ARM Group Inc.

Re: Interim Use Work Plan:
Marketing Center
Area B: Sub-Parcel B6-2 (Retail Area)
Comment Response Letter
Tradepoint Atlantic
Sparrows Point, MD 21219

Responses to MDE Comments:

Figure
3

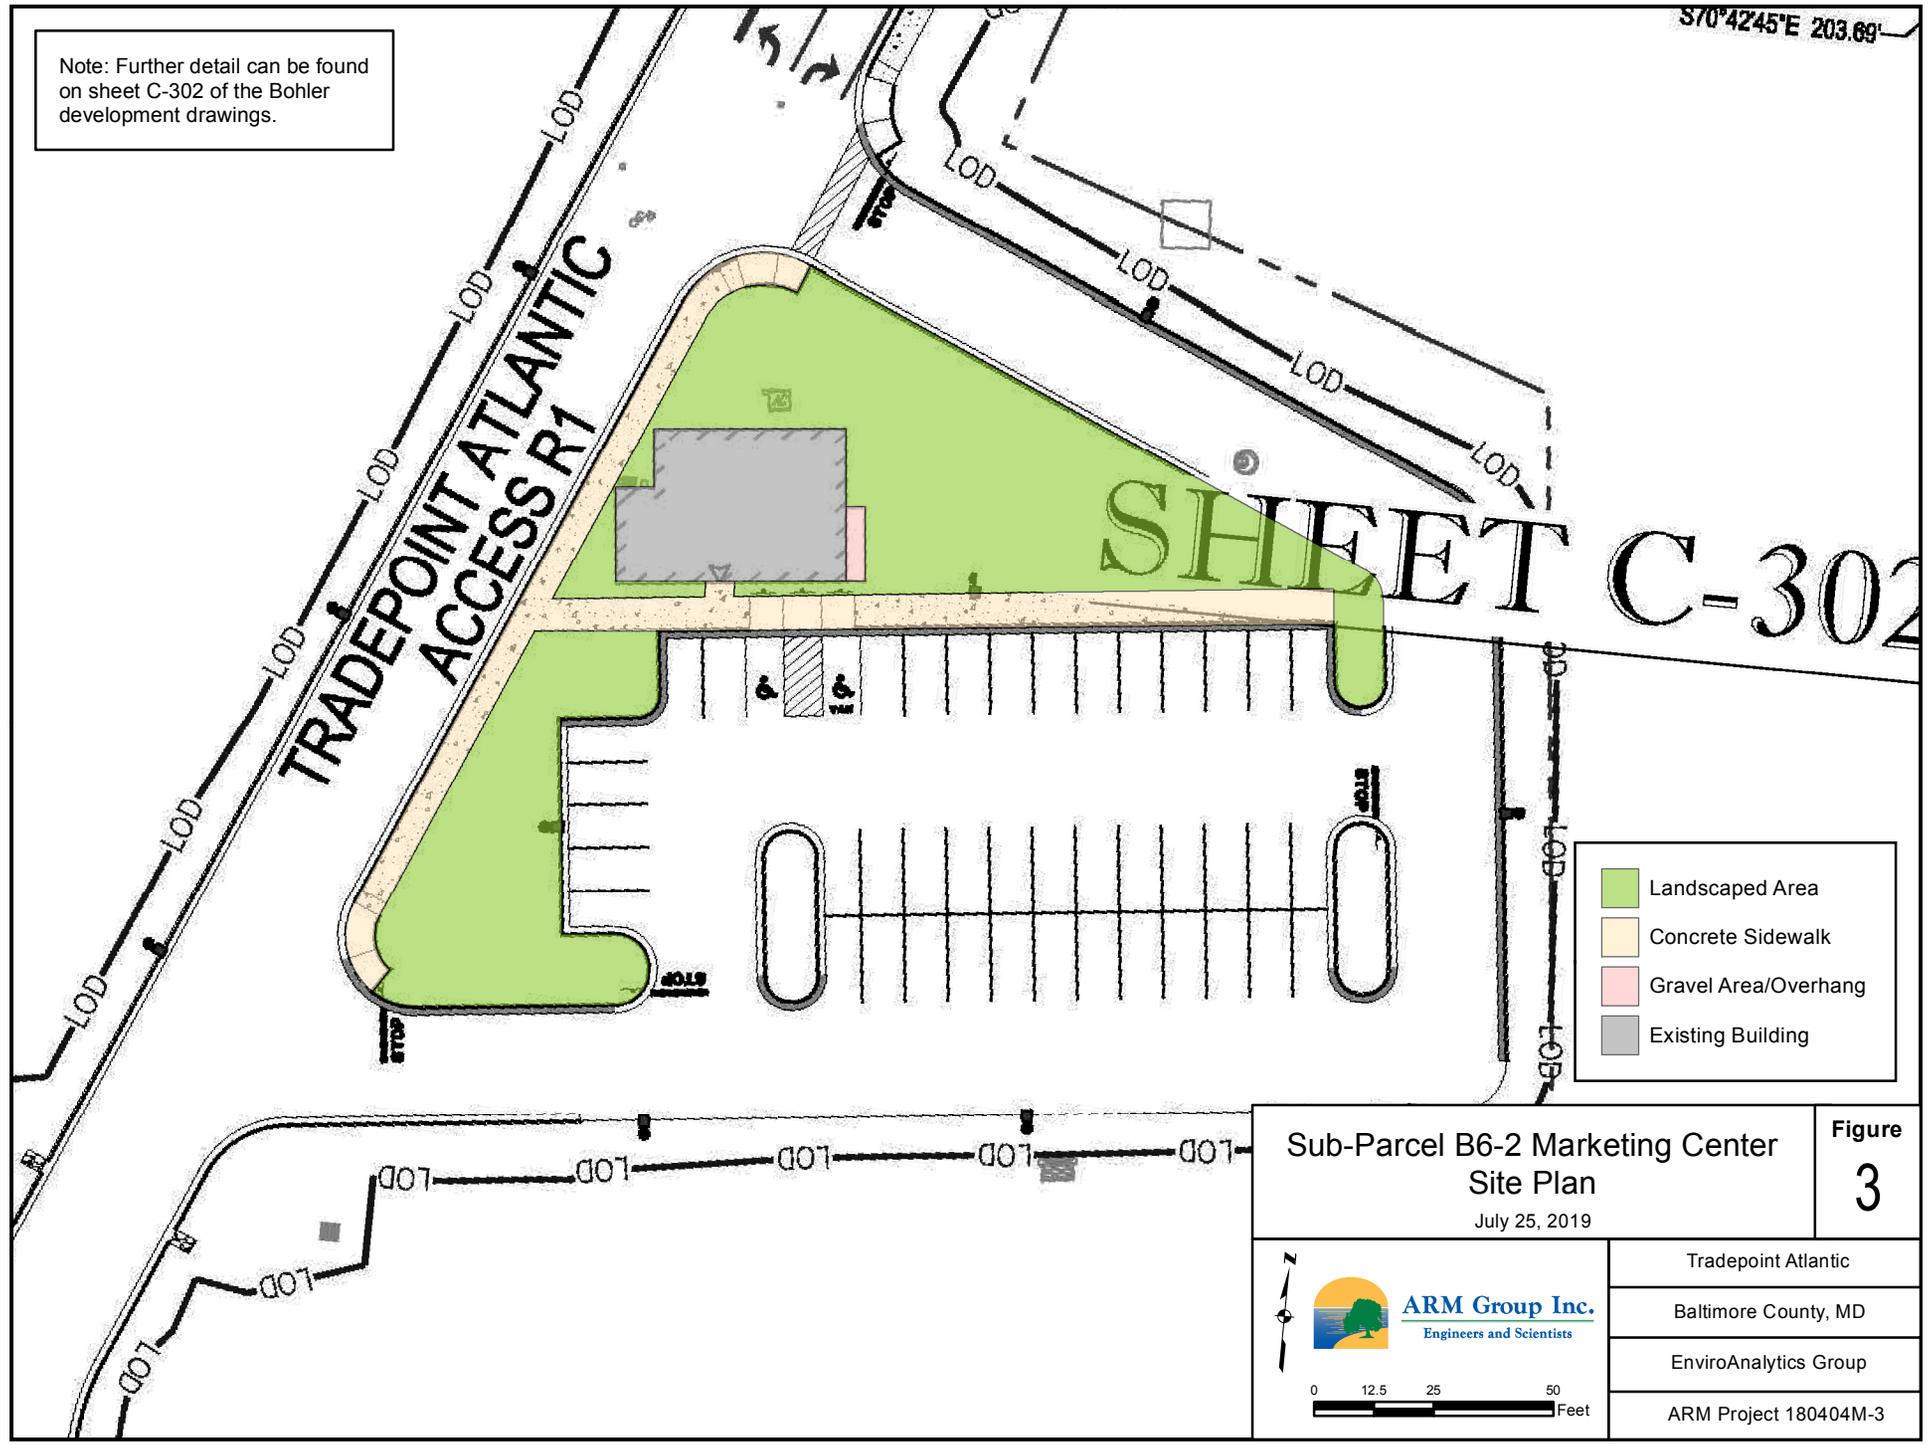
4. Will the Marketing Center be fenced off from the remainder of the site? Fenced off with the adjacent Royal Farms? The RDWP Addendum Rev. 2, Retail Area No. 1 stated that all adjacent areas to the Royal Farms site would be temporarily landscaped until later development occurs. Some of this area included the surrounding Marketing Center. Once this project and the Royal Farms project are complete, will any uncovered slag remain within the boundary of TPA Access Rd. 1 and Access Rd. 2?

The referenced RADWP Addendum stated that the Royal Farms would be fenced off from the surrounding uncapped areas using “non-ground intrusive chain link temporary storm fencing”. However, this approach was developed before the capping plan for the Marketing Center was known. Based on the updated plan, all areas enclosed within the ingress/egress roads will be capped, either with permanent caps (i.e., pavement or landscaping) or temporary caps (i.e., crushed concrete) as shown on the attached **Figure 5**. No areas of uncovered slag will remain exposed within these roads. Therefore, fences are not proposed surrounding the Marketing Center (and are no longer proposed surrounding the adjoining Royal Farms). It is not anticipated that visitors to the Marketing Center or Royal Farms will traverse the Site to areas outside of the access roads. The southernmost road running from east to west will adjoin with the border of the Tin Mill Canal (TMC), which has already been capped by the maintenance cleanup work that was recently completed. The roads will be physically separated from the TMC by a 4-foot high fence.

drawing title	CAPPING SECTION DETAILS
	SPARROWS POINT AREA B ENVIROANALYTICS GROUP
project title	SPARROWS POINT BALT. COUNTY, MARYLAND
	F

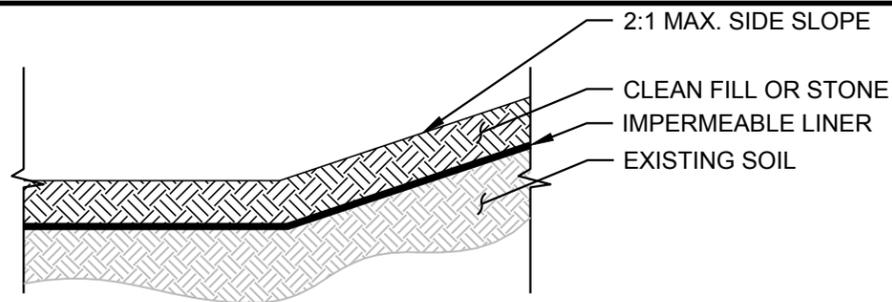
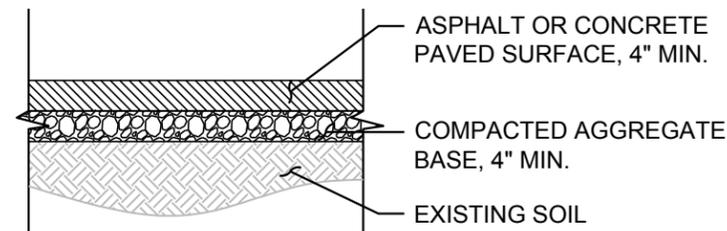
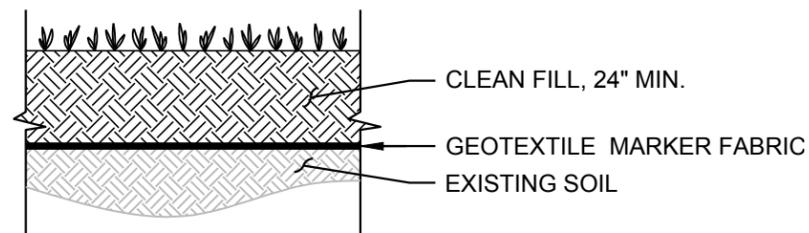
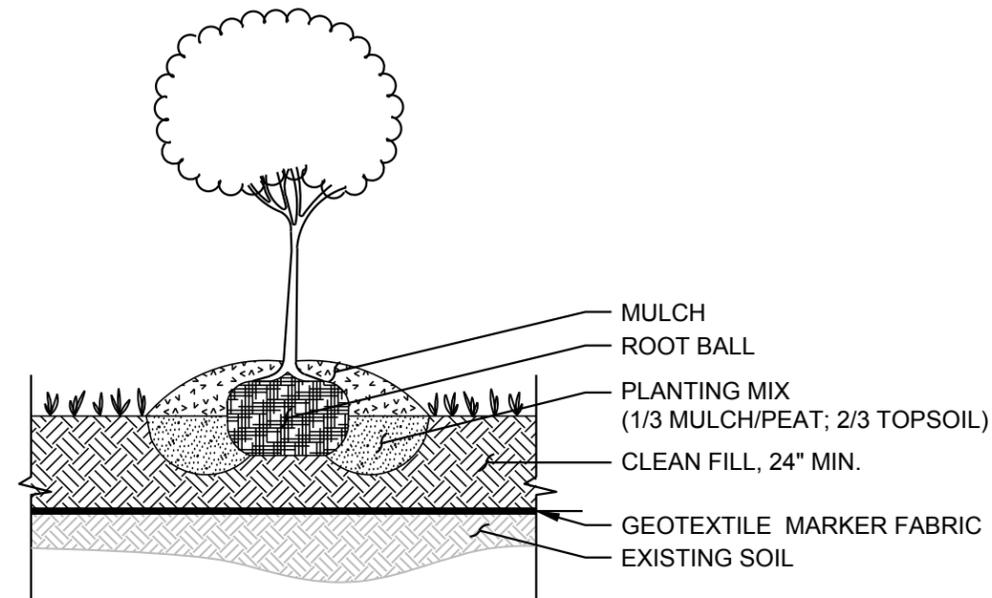
- a. *Add statements re: the general minimum requirements approved for capping material in the B6-2 RDWP (ex: 2' of clean fill beneath all landscaped areas with an underlying geotextile fabric marker, 4" of pavement cover over 4" approved subbase material).*

3. It would be useful to include the approved cap minimum drawings from the approved RDWP along with the engineering drawings provided by Bohler.

The capping remedies will meet the minimum thicknesses specified in the Sub-Parcel B6-2 RADWP (Revision 1 dated January 24, 2018). Specifically, all paved areas will be installed with a minimum of 4 inches of compacted aggregate base and a minimum of 4 inches of overlying pavement surface. Landscaped areas will consist of a minimum of 2 feet of clean fill (meeting VCP requirements for commercial land use) over a geotextile marker fabric prior to being planted. Trees will be installed with a minimum of 2 feet of clean fill (meeting VCP requirements for commercial land use) around the root ball, with a geotextile marker fabric placed between the clean backfill and underlying soils.

The Capping Section Details from the approved Sub-Parcel B6-2 RADWP are provided with this letter as **Attachment 1**.
